## MEMORANDUM

**Date:** 11/4/2016  
**To:** Planning Commission  
**From:** Michele T. Morris, Assistant Planner  
**Re:** 120 Chester Street – Determination of Substantial Conformance

**Proposed Front Elevation (North)**

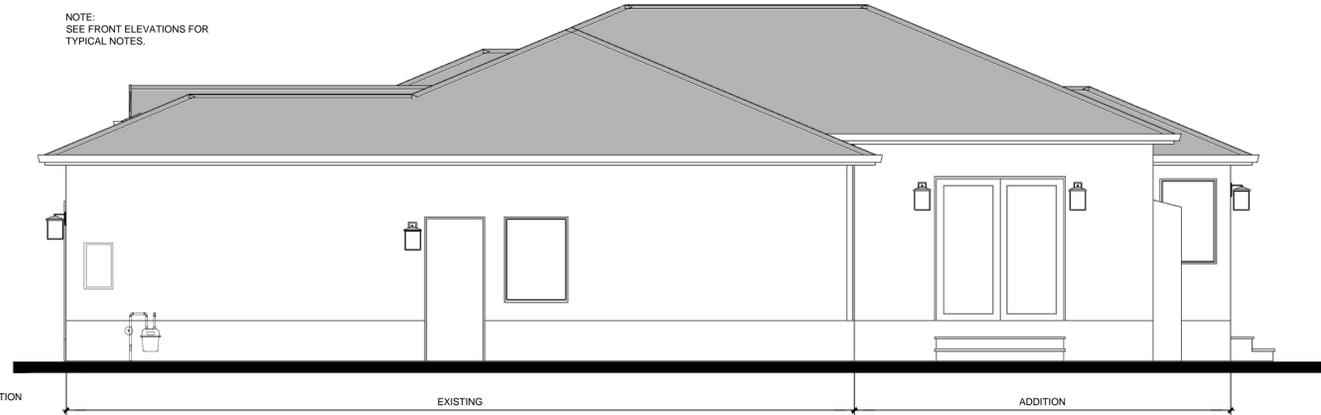
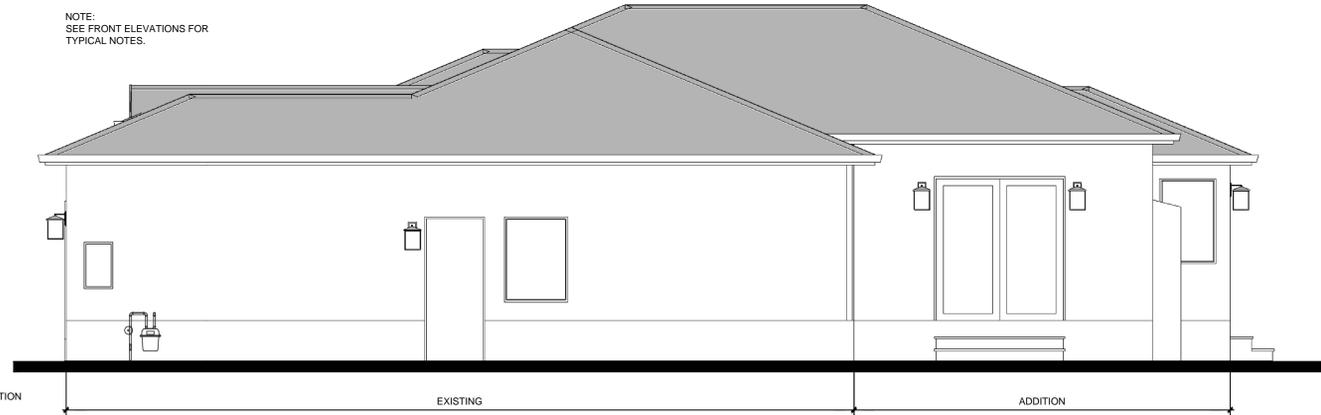
The applicant is requesting to modify the approved elevations (Attachment A) by changing the type of windows on the left side of the front façade. The proposed bedroom windows would change from fixed, vinyl-framed casement windows to a bay window consisting of two single-hung windows on each side of a fixed window. The new bay window would be cantilevered and would not add more floor area to the floor area limit. The roof line would be modified to create an overhang above the new bay window. The new windows would also include vinyl frames with wood trim. The applicant states that the proposed bay window would create a more open space in the bedroom and add character to the front of the proposed residence. The applicant has submitted a project description letter and revised elevations, included as Attachments B and C, respectively.

The front bedroom had an existing 7' wide window that we want to replace with a 7' wide cantilevered bay window. The reason was to make the room feel more open and add some character to the front of the house to break up all the flat walls.

Staff has determined that the changes to the project plans are in substantial conformance with the Planning Commission's previous use permit recommendation based on the following:

- The modification of the bedroom windows and roof line would not affect the overall integrity of the architectural design of the house.
- The project modification meets all development regulations in the R-1-U zoning district with respect to setbacks, height, daylight plane, floor area limit, and building coverage.
